MFN 10-089 Revision 1

Subject: **Revised Response to NRC RAI Letter No. 409 Related to ESBWR Design Certification Application – DCD Tier 2 Section 10.2 – Steam and Power Conversion System; RAI Number 10.2-18 S03**

DCD Tier 2 Section 10.2 – Steam and Power Conversion System

RAI Number 10.2-18 S03

[Figure 2.11.1-1. TMSS Functional Arrangement](#)

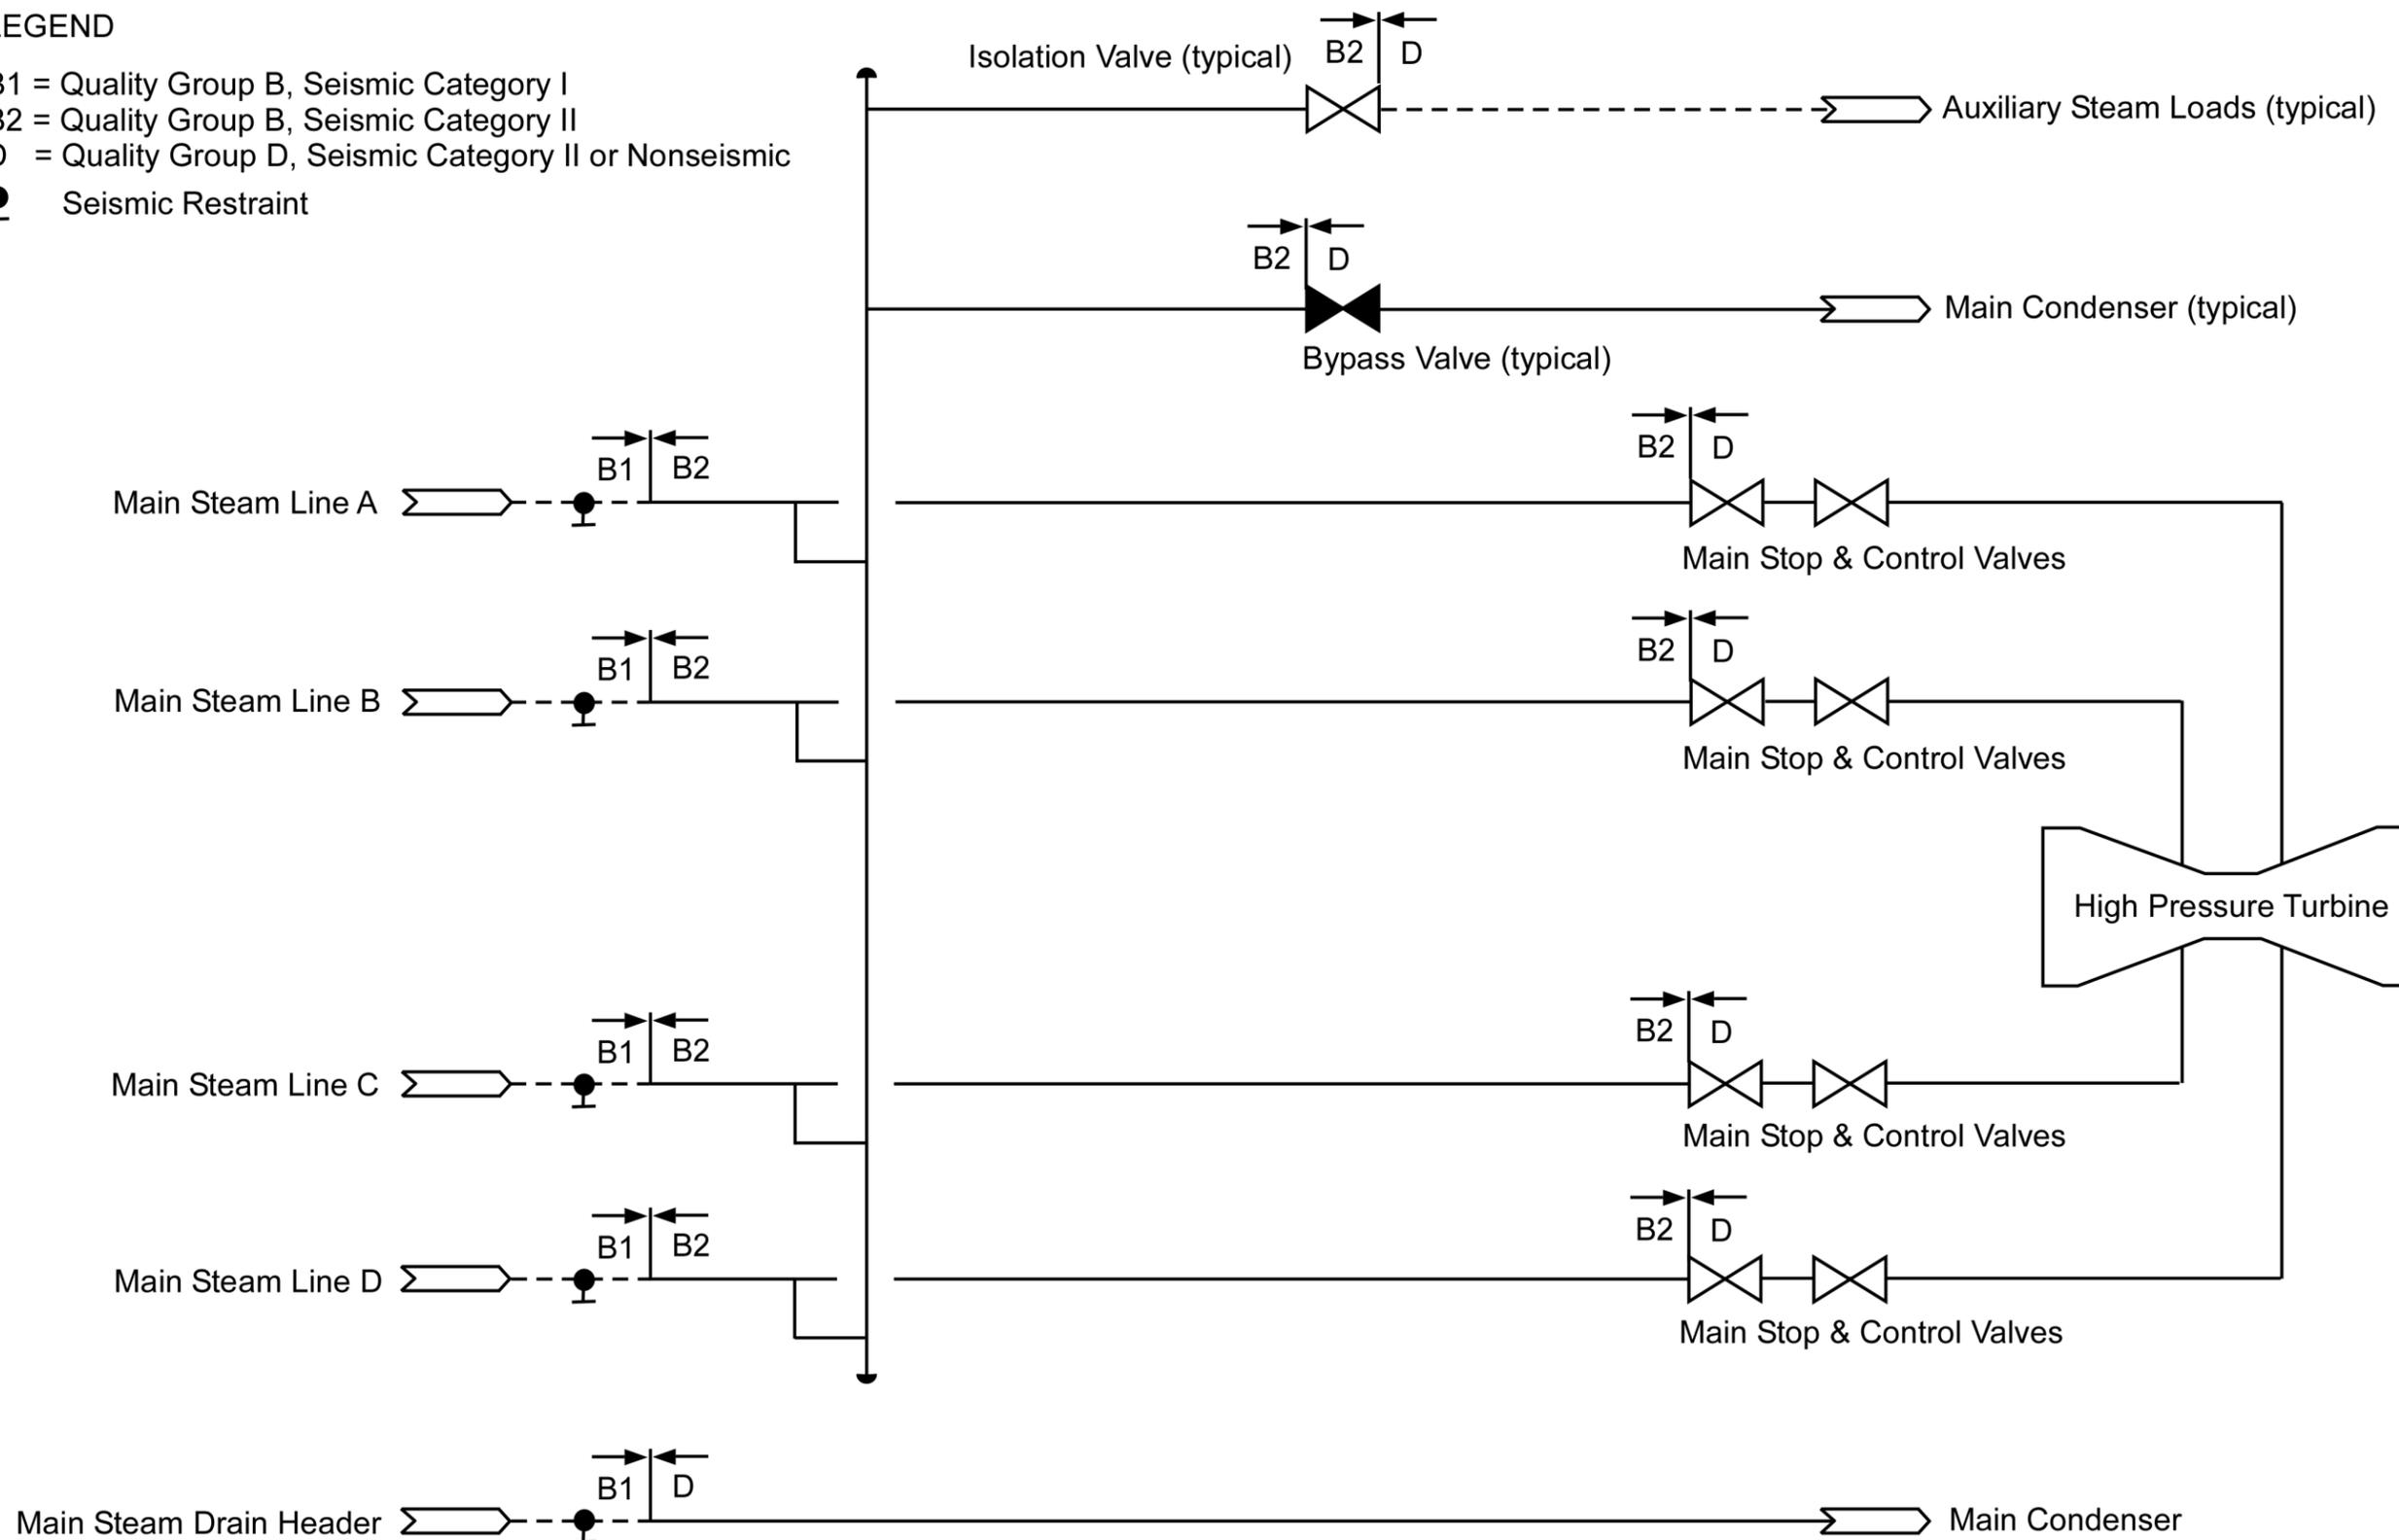
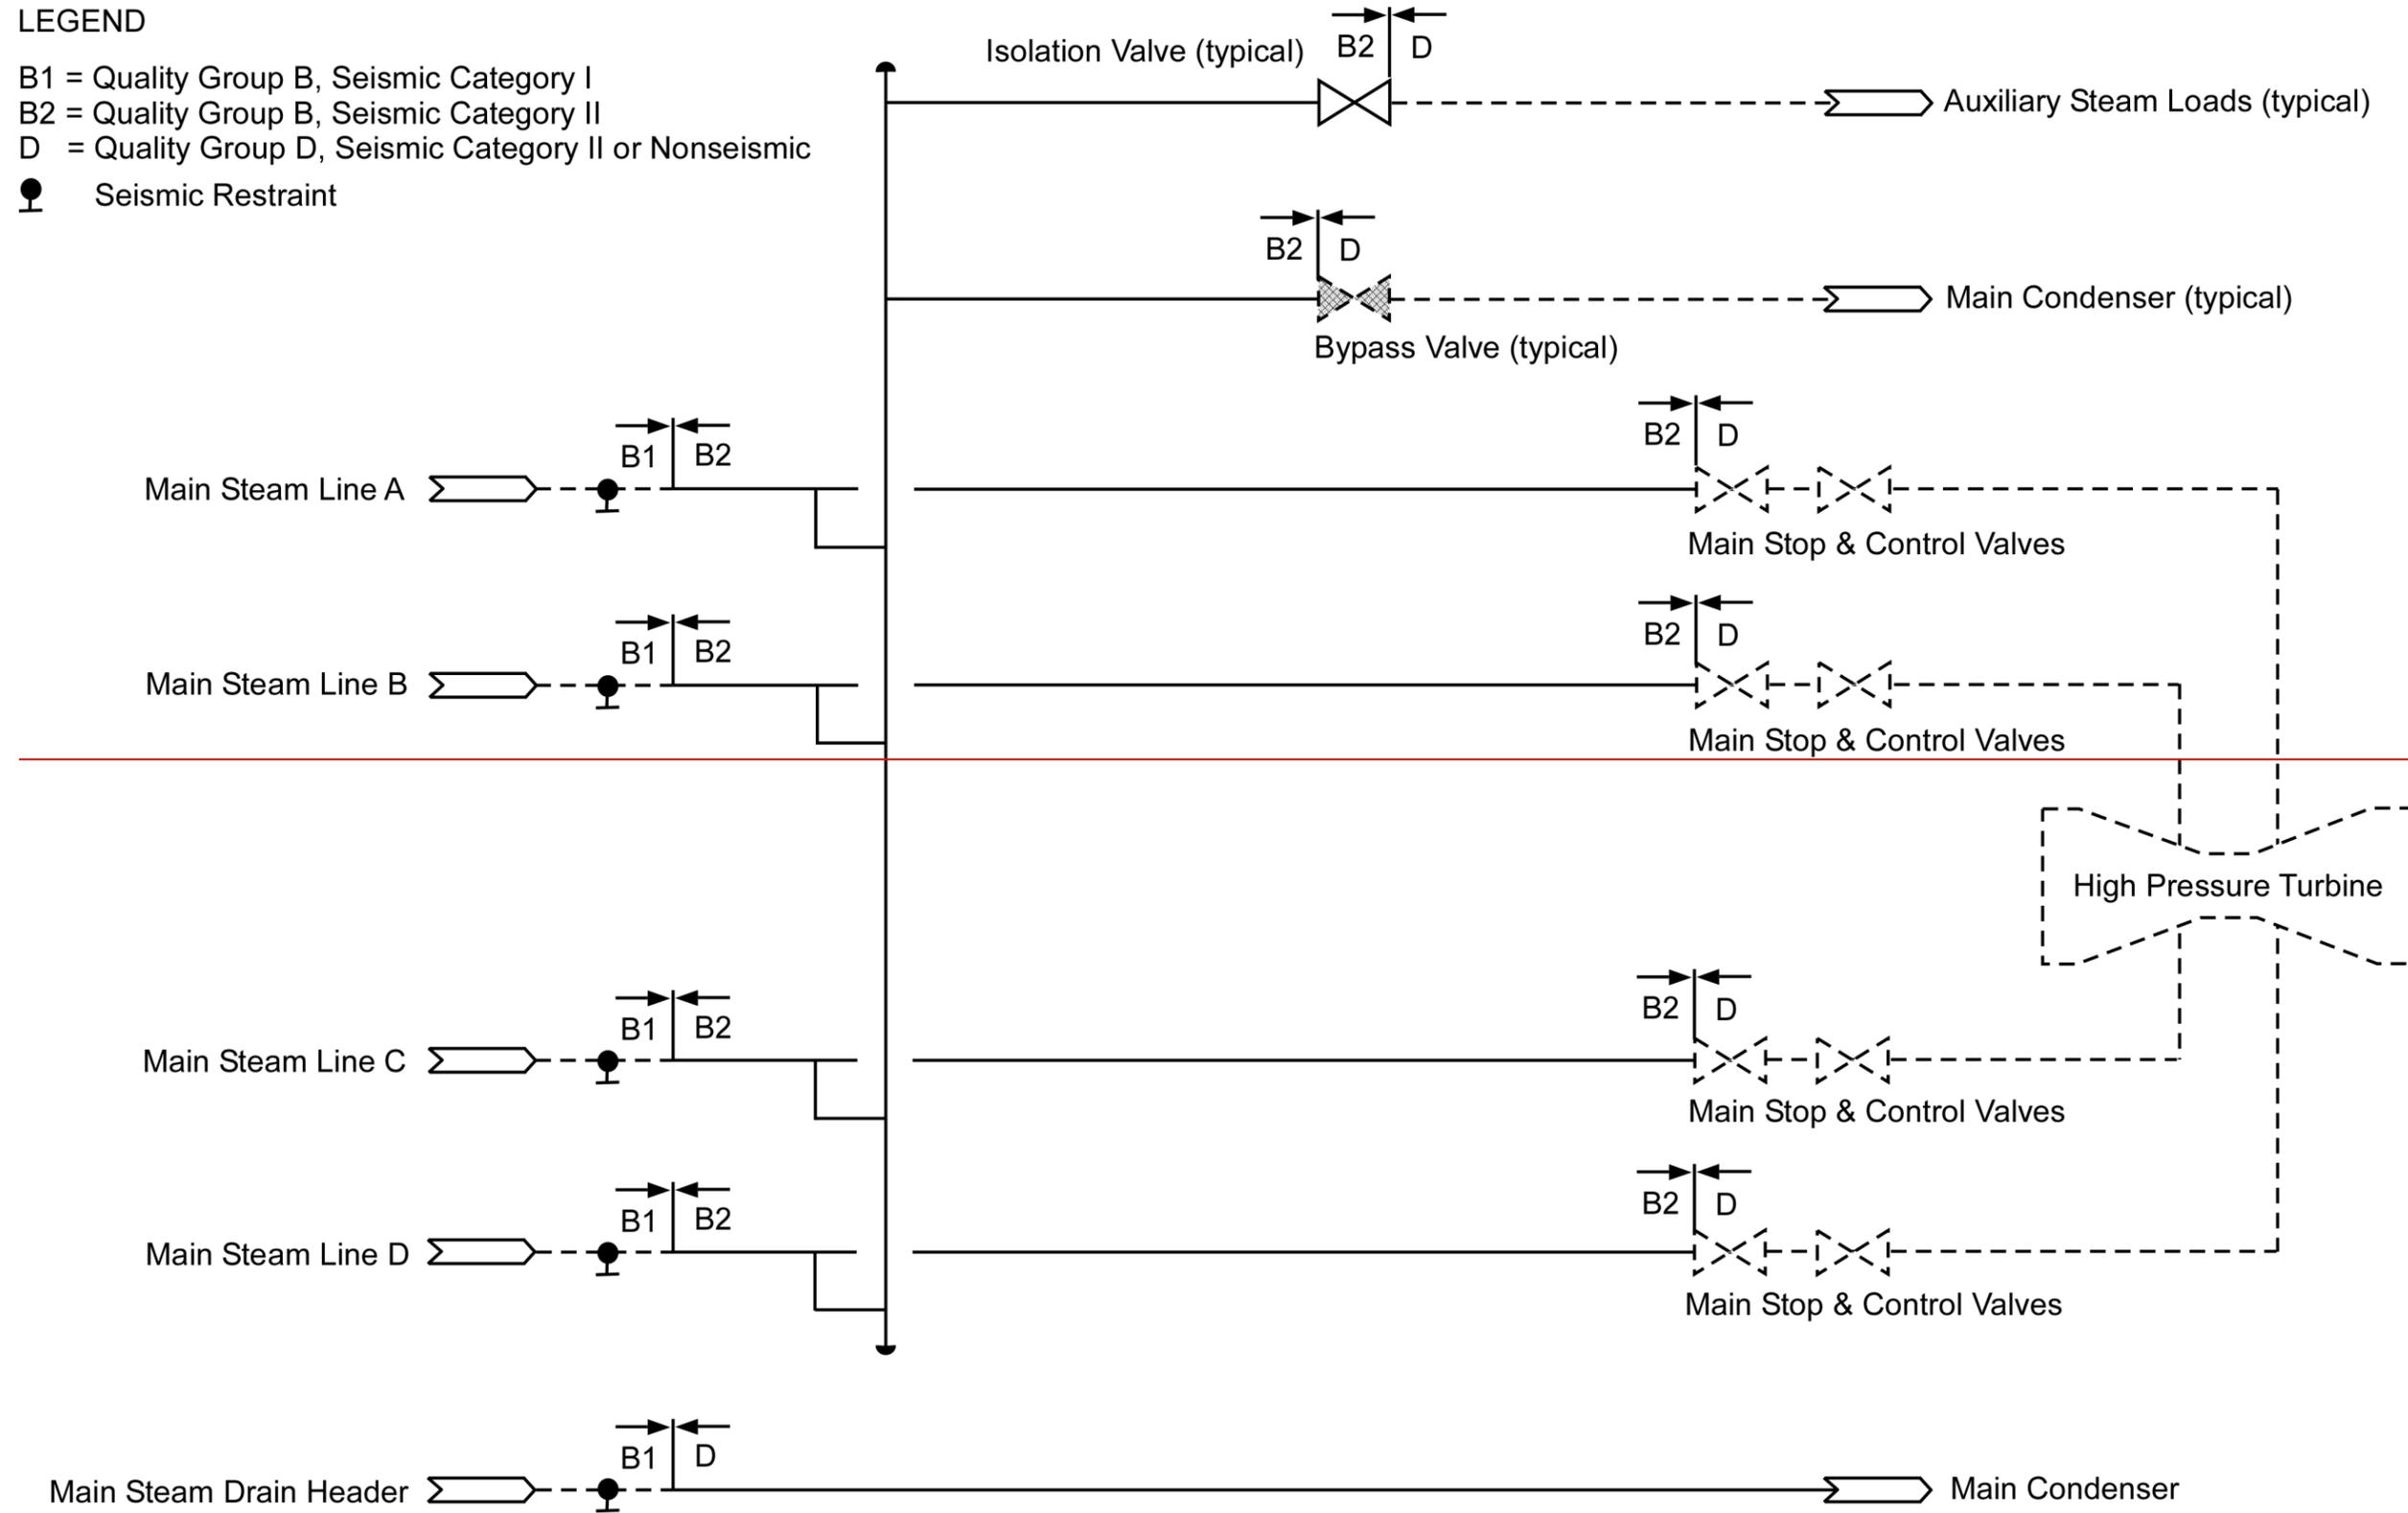
12) An ITAAC is needed to verify the layout/locations of turbine stop, control, intermediate stop, intercept, and extraction non-return valves.

DCD Tier 1 Subsection 2.11.1 covers the proposed DCD Tier 1 design description, Table 2.11.1-1 and Figure 2.11.1-1, -2, and -3 diagrams that verify the layout/locations of turbine stop, control, intermediate stop, intercept, and spring assisted extraction non-return valves. The DCD Figure 2.11.1-2 has the exhaust steam and extraction steam lines labeled to preclude confusion on location. Simple check type non-return valves installed on extraction lines are not required to be shown in the DCD or Tier 1 since they do not have a function in turbine overspeed protection.

- (6) The integrity of the as-built MSIV leakage path to the condenser (main steam piping, bypass piping, required drain piping, and main condenser [as shown on Figure 2.11.1-1](#)) is not compromised by non-seismically designed systems, structures and components.
